Certificate of Appropriateness

2112 N. LAKE DR. North Point South Historic District

PTS ID 93311 COA, screening and install of rooftop generator and a/c units

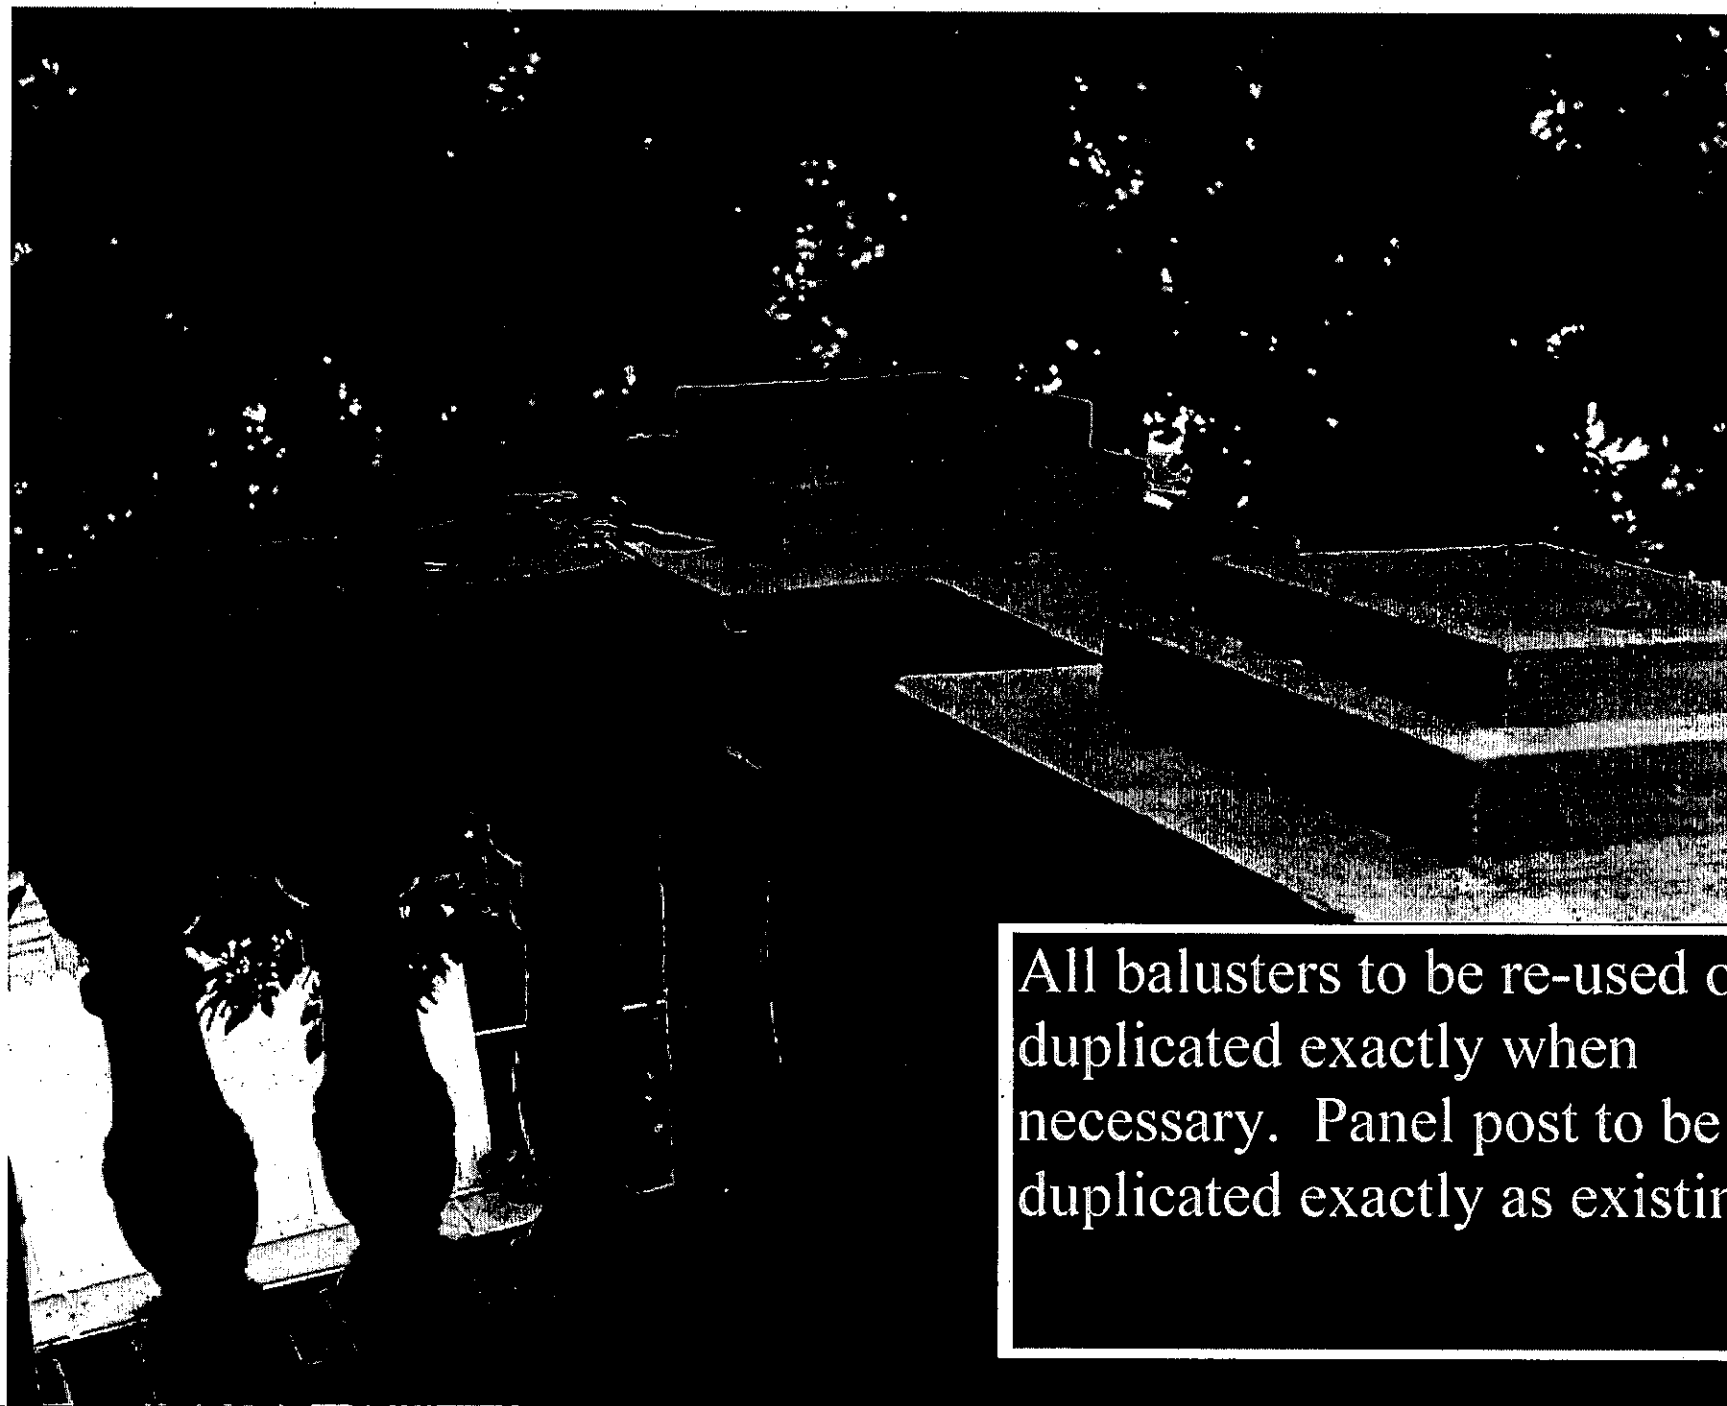
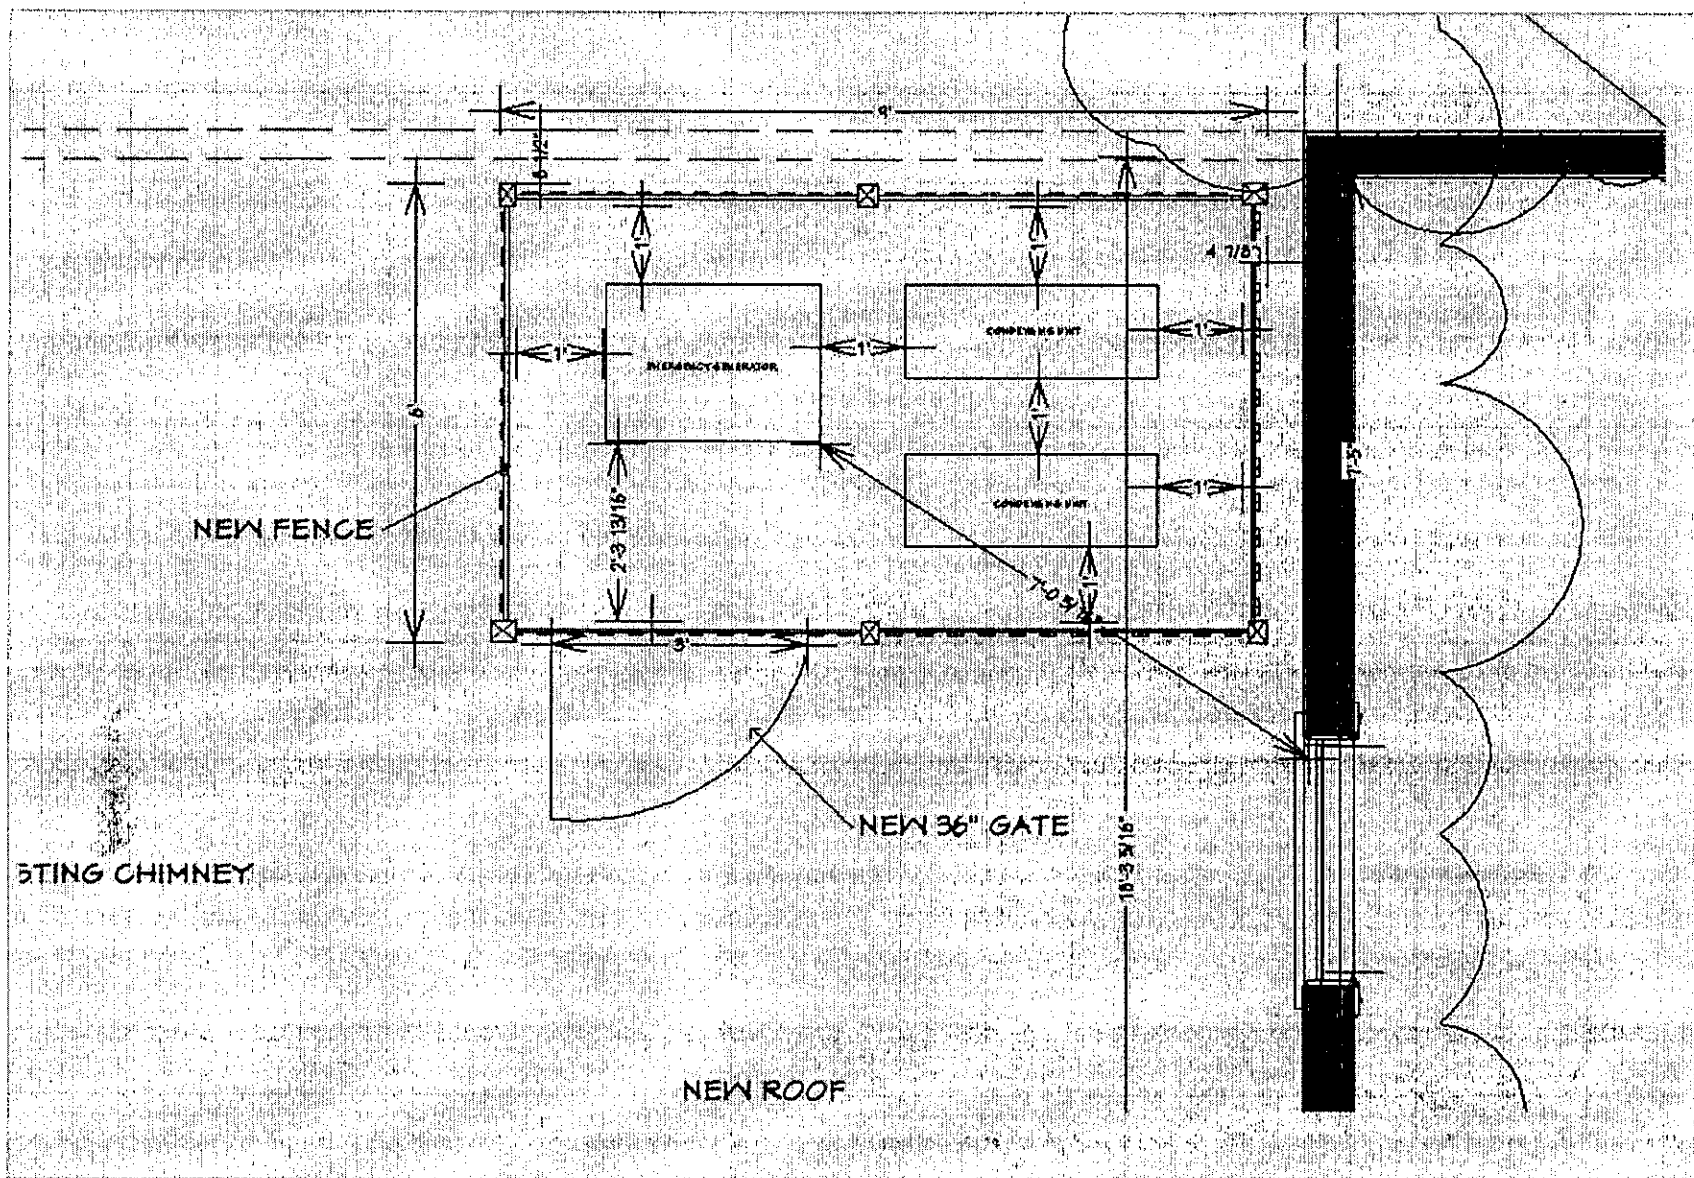
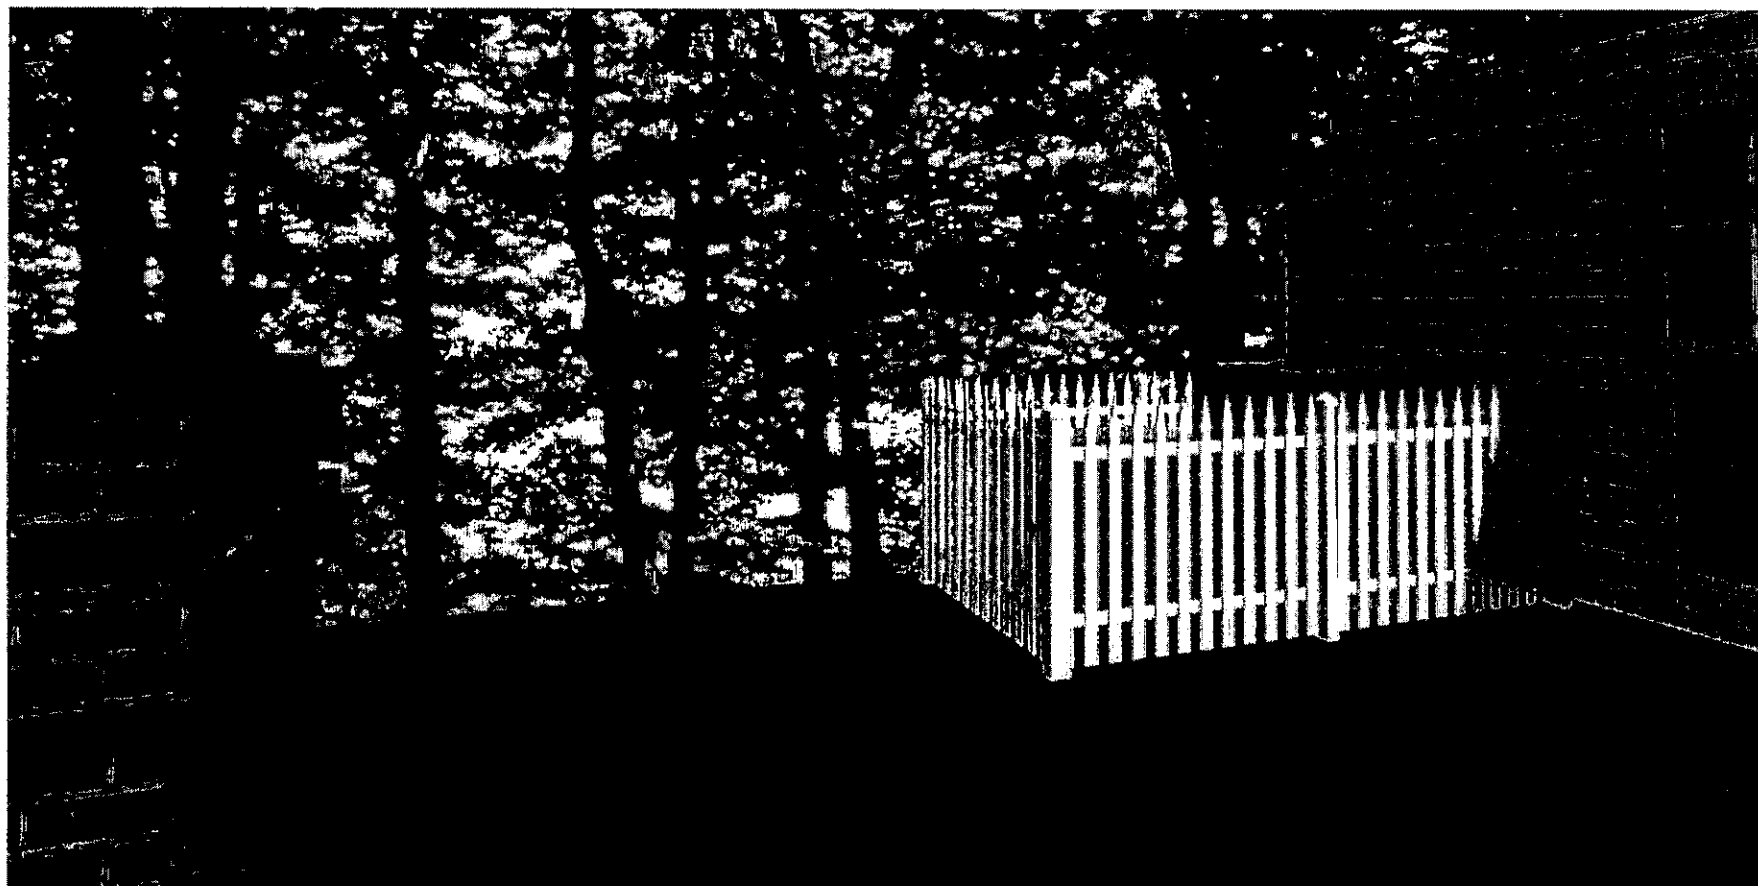
Corner posts on front porch roof
to be replaced to match existing
design See detail photo below.

All balusters to be re-used or duplicated exactly when necessary. Panel post to be duplicated exactly as existing.

PROPOSED RENDERING - KIEFFER RESIDENCE

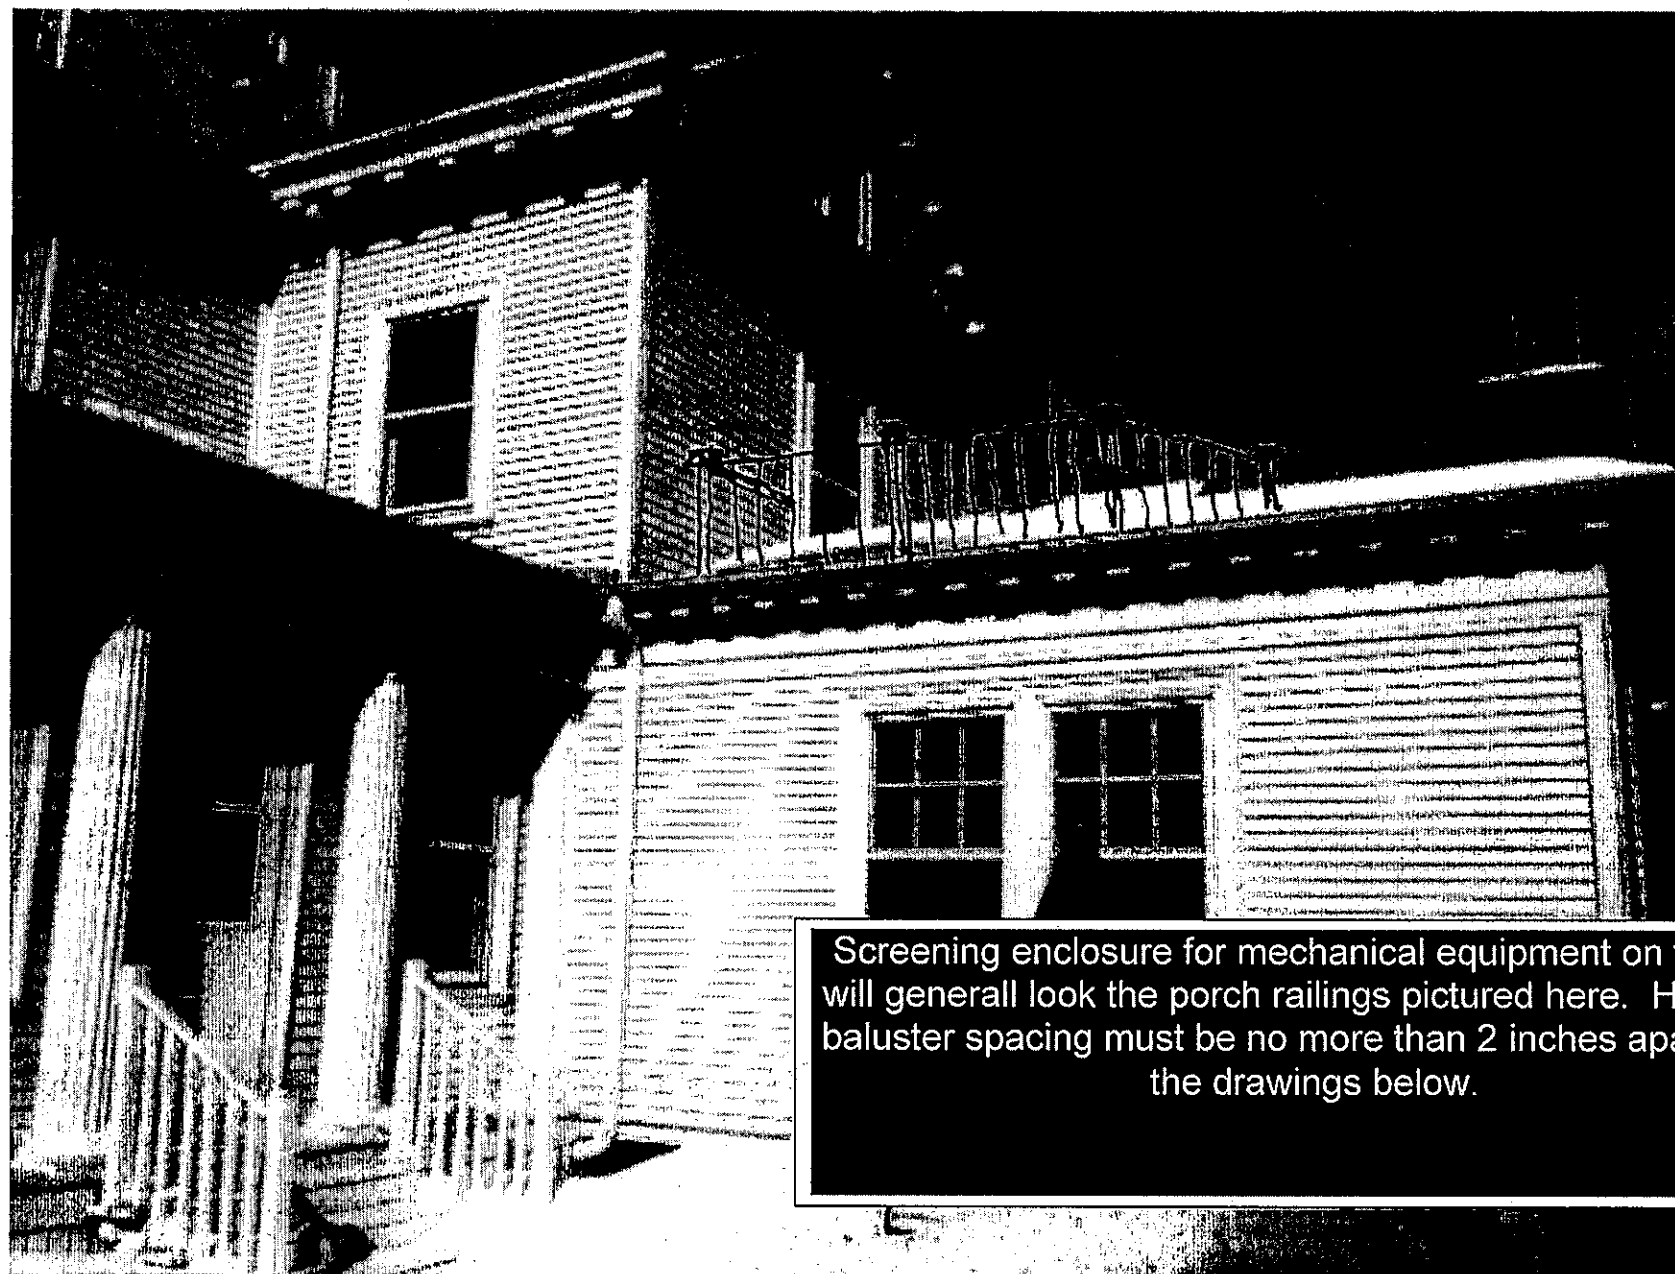
FENCE IS NOT ACTUAL - SEE MATERIALS SELECTED

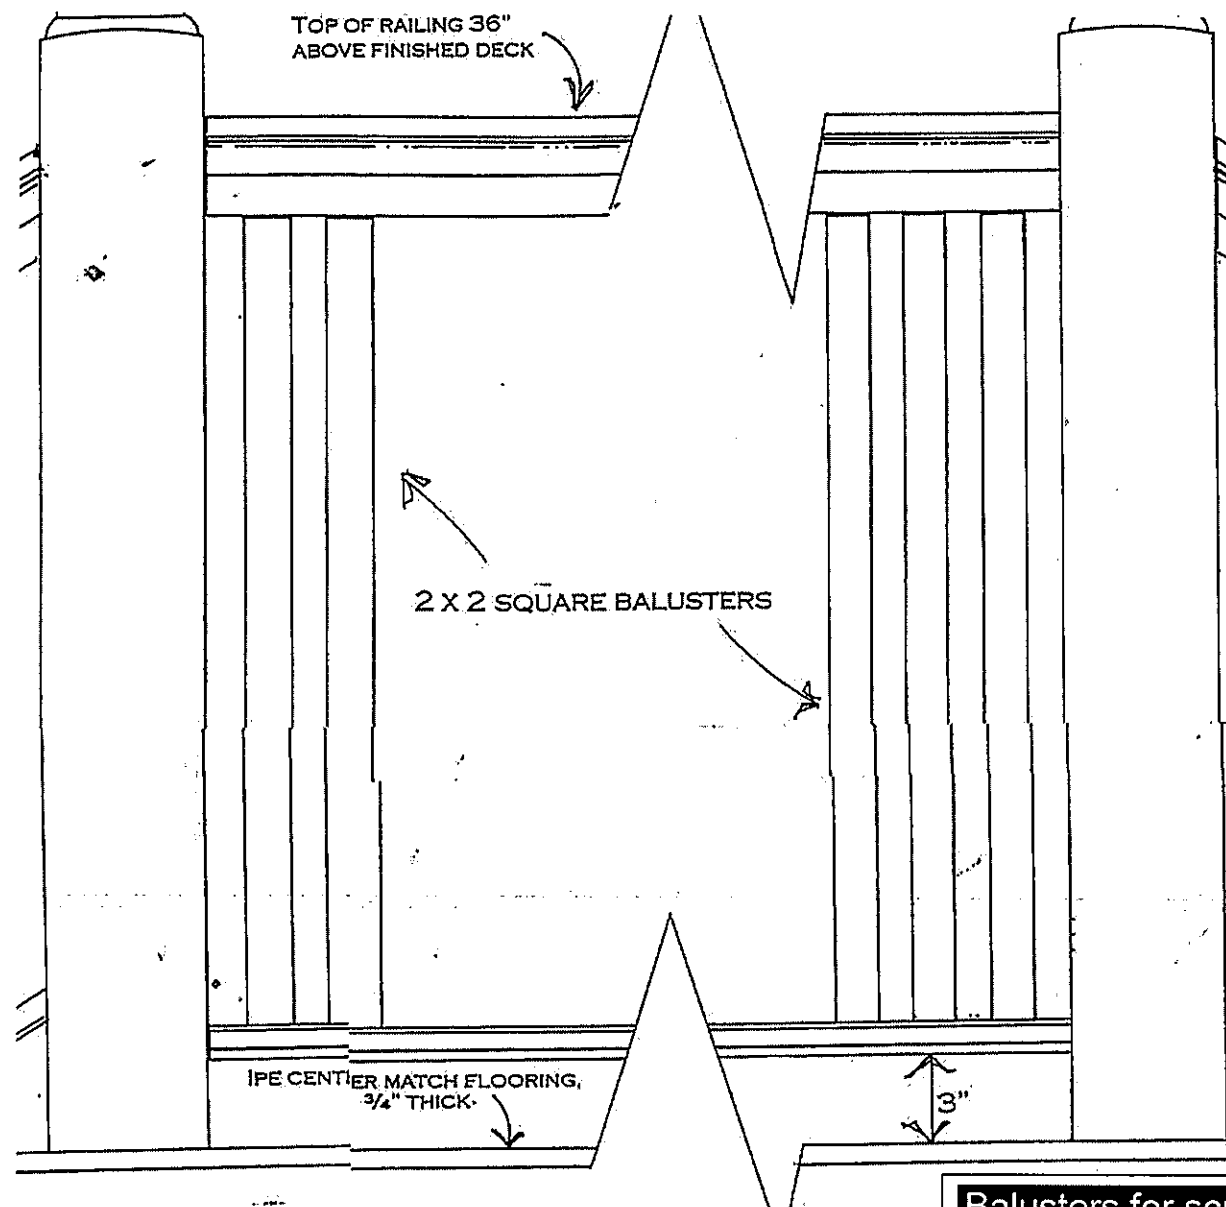
Screening enclosure for mechanical equipment on flat roof will generally look the porch railings pictured here. However, baluster spacing must be no more than 2 inches apart. See the drawings below.

Balusters for screening enclosure will be 2x2 square and spaced no more than 2 inches apart
